EPRI NP-5283-SR-A
Special Report
September 1987

Guidelines for Permanent BWR Hydrogen Water Chemistry Installations—1987 Revision

BWR Owners Group for IGSCC Research
Hydrogen Installation Subcommittee

Figure 4-2 Minimum required separation distances to safety-related structures versus vessel size for gaseous hydrogen storage system.

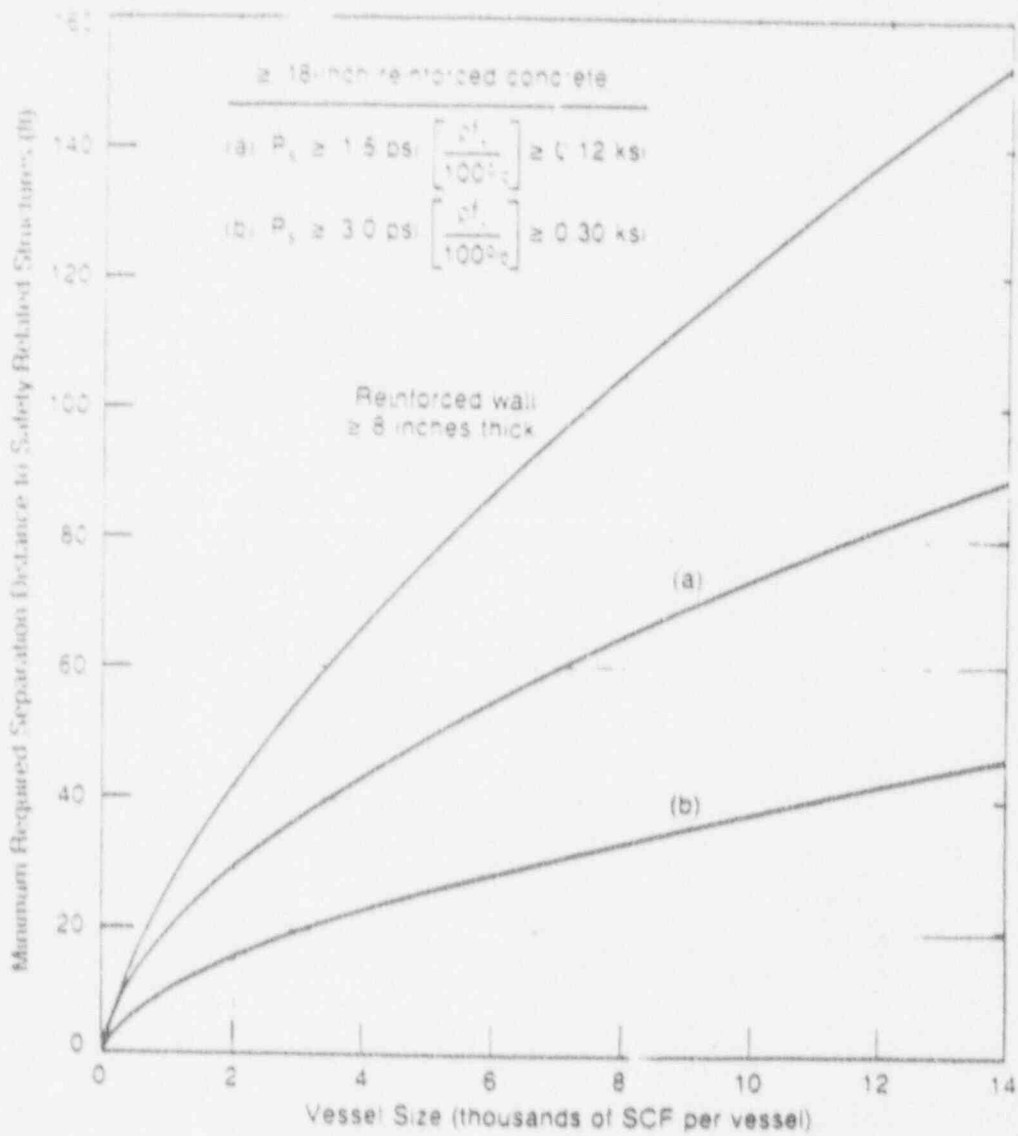
The staff reviewed the separation distance for hydrogen storage facilities with 8-inch or greater reinforced concrete or reinforced masonry walls (upper curve in Figure 4-2 and 4-5 of the Guidelines). This curve is based on the British Explosives Storage and Transport Committee's recommendations (New York Academy of Sciences Annals, Vol. 1, 152, 1968). On the basis of this review, the staff concludes that the recommendations are reasonable and valid. The staff finds there are ample data from well-documented explosion experiments, damage records from accidental explosions, and war-time experiences (bomb damage), all of which were considered in the formulation of the recommendations.

The Guidelines provide separation distance from hydrogen storage facilities for 18-inch or greater reinforced concrete walls (curves (a) and (b) in Figures 4-2 and 4-5 of the Guidelines). Curves (a) and (b) are applicable for the indicated static pressure capacities and tensile steel factors, and are acceptable by the staff. The method of analysis for constructing these curves is conventional and generally follows the guidelines of the American Society of Civil Engineers (ASCE) Manual No. 58 (1980) and American Concrete Institute (ACI) 349-80 (April 1981).

Figure 4-4 Thermal flux versus distance from fireball center for liquid hydrogen storage system.

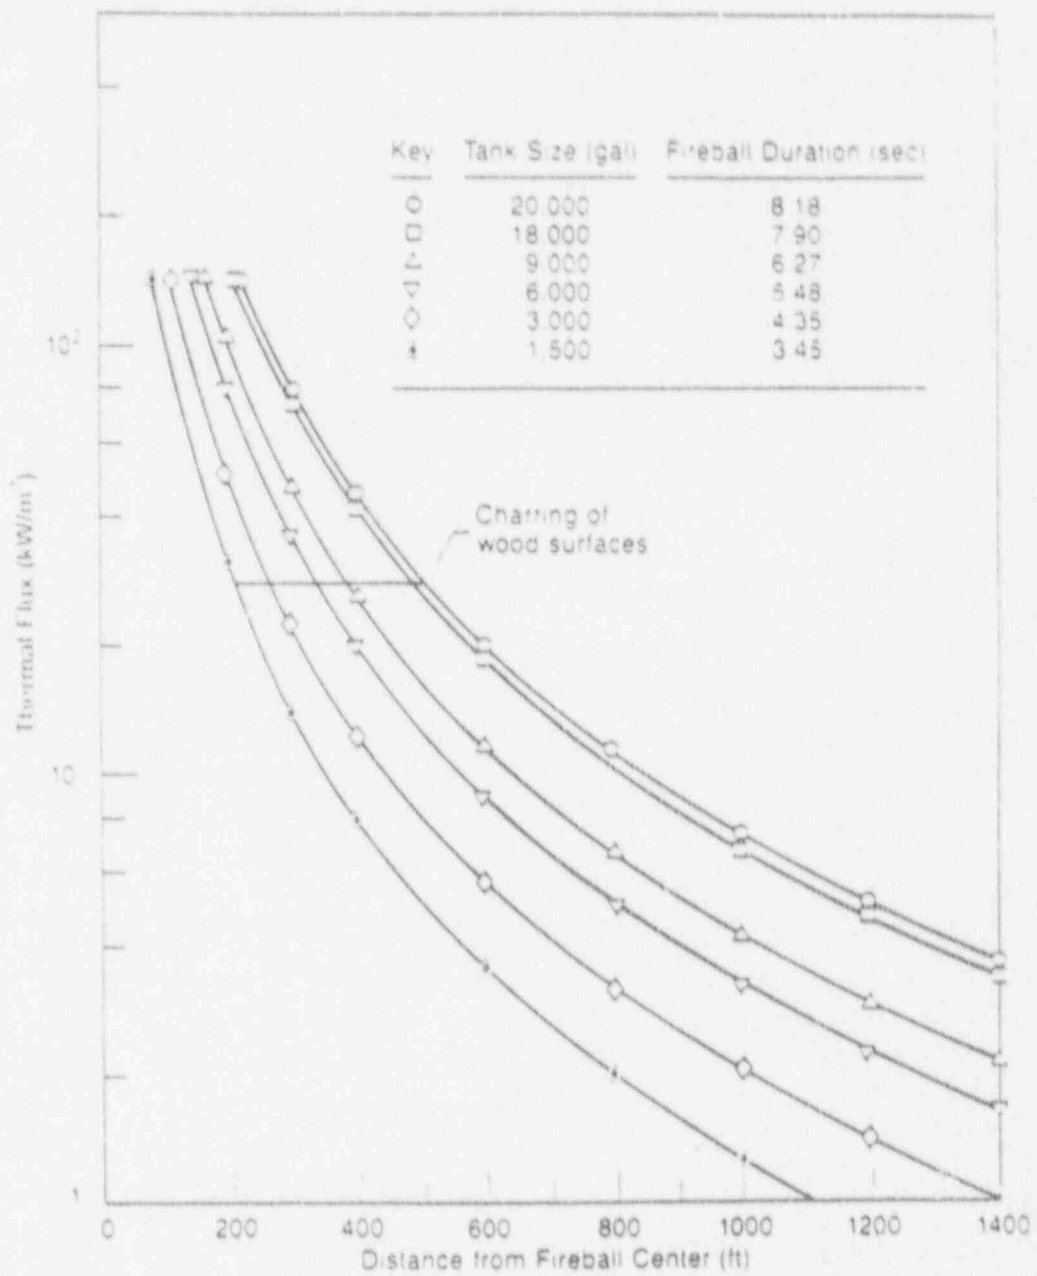
The staff has performed independent calculations to check the values shown in the Guidelines. The staff used NASA data to check the thermal flux data (Figure 4-4 in the Guidelines). Standard meteorological data were used to check the hydrogen concentrations at the nearest safety-related air intakes (Figure 4-6 in the Guidelines). The staff used the Guidelines (Hoehne and Luck, 1970) to determine the lower flammable concentrations from various sizes of pipe breaks in gaseous hydrogen lines. In addition, the staff noted blast overpressure effects on both reinforced brick houses and reinforced concrete houses from nuclear weapons tests. The staff also observed that the 5 psi overpressure that destroyed an unreinforced brick house had no effect on a reinforced concrete house that had been designed to comply with California Code for earthquake-resistant construction (Glasstone, 1962). These data indicate that Figure 4-5 of the Guidelines is conservative when it is applied to safety-related structural walls.

Figure 4-5 Minimum required separation distance versus liquid hydrogen storage tank size for instantaneous release of entire tank contents and explosion at tank site F weather stability

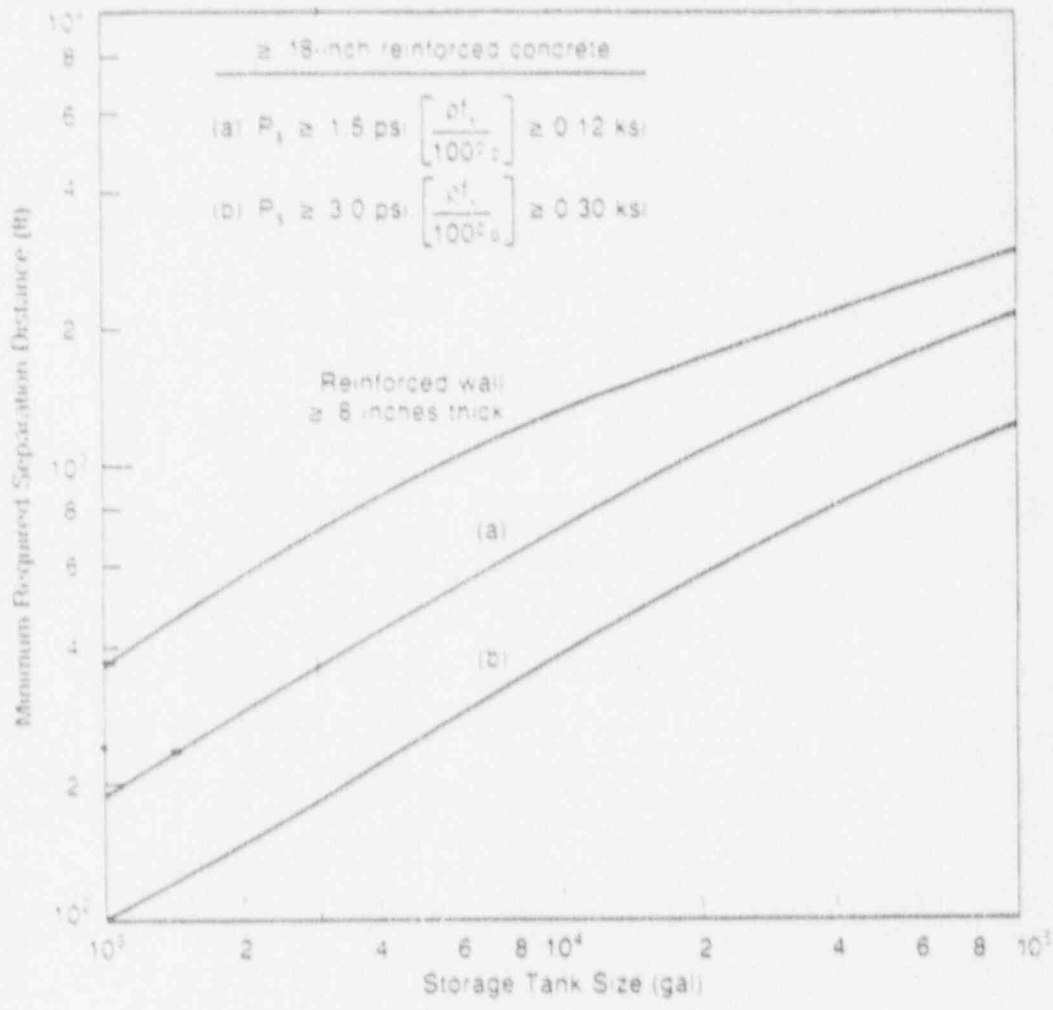
Licensees may use the minimum separation distance curves in Figure 4-5 of the Guidelines in requests for approval of permanent hydrogen water chemistry installations.

Figure 4-6 Minimum required separation distance versus hole size and ID of pipe for gaseous releases from 150 psig liquid hydrogen storage tank

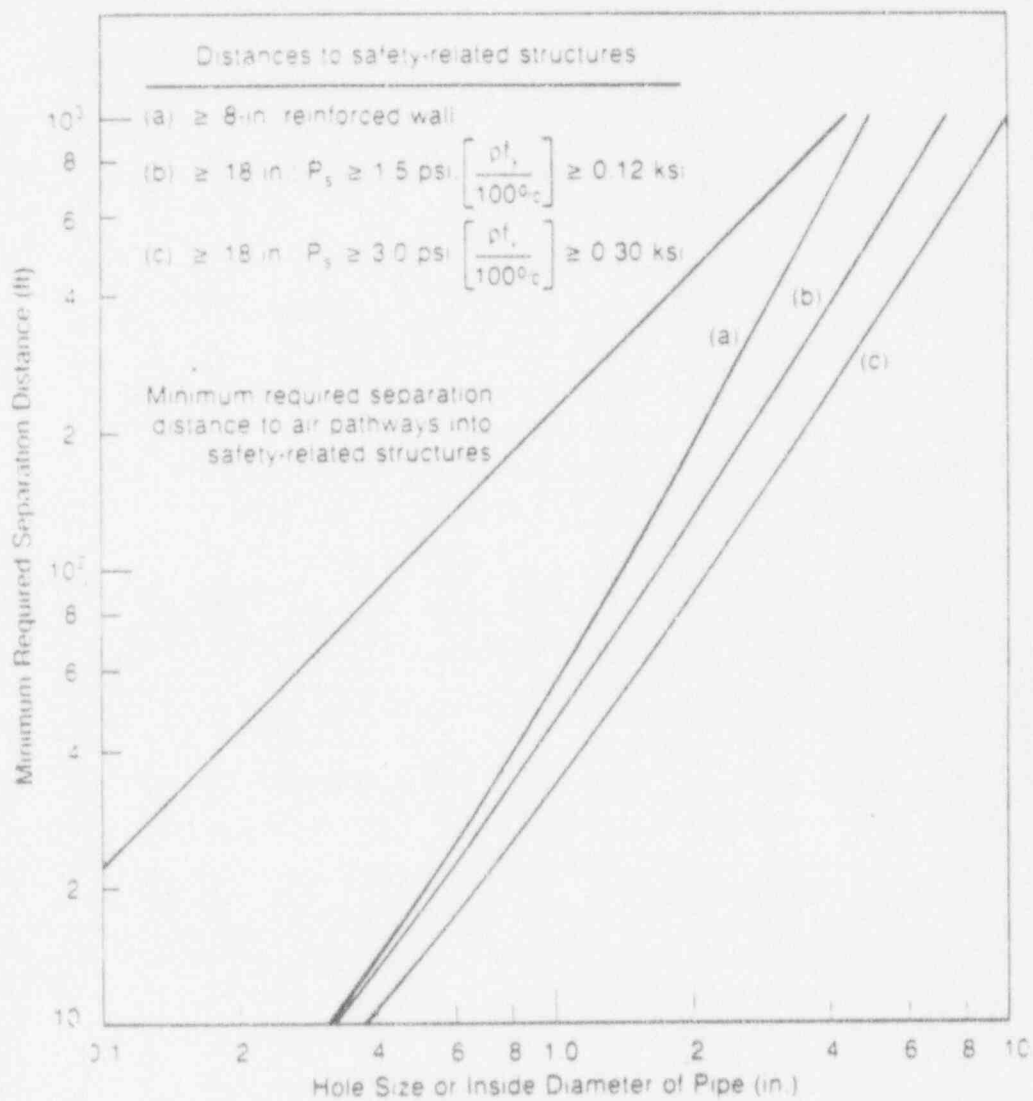
Licensees may use the minimum separation distance curves in Figure 4-6 of the Guidelines in requests for approval of permanent hydrogen water chemistry installations.

Figure 4-8 Acceptable locations of safety-related air intakes for various sizes of liquid oxygen storage tanks.

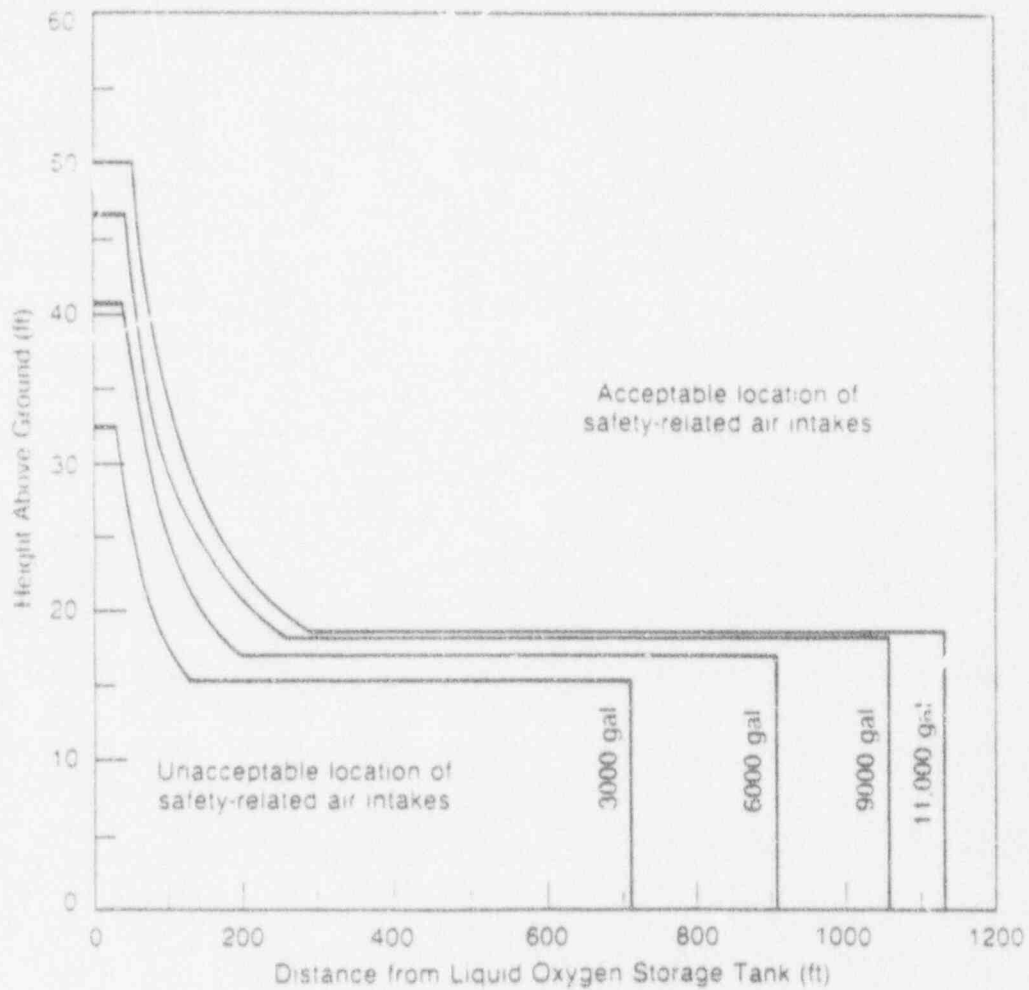
The liquid oxygen tank capacity versus distance curves were checked by independent staff analysis and found to be acceptable (Figure 4-8 of the Guidelines). The recommended separation distances between liquid storage tanks and safety-related air intakes are reasonable. The separation distances are such that the vapor cloud released from a failed tank would disperse sufficiently so that the oxygen content at the air intakes will not support increased combustibility of ignitable materials.
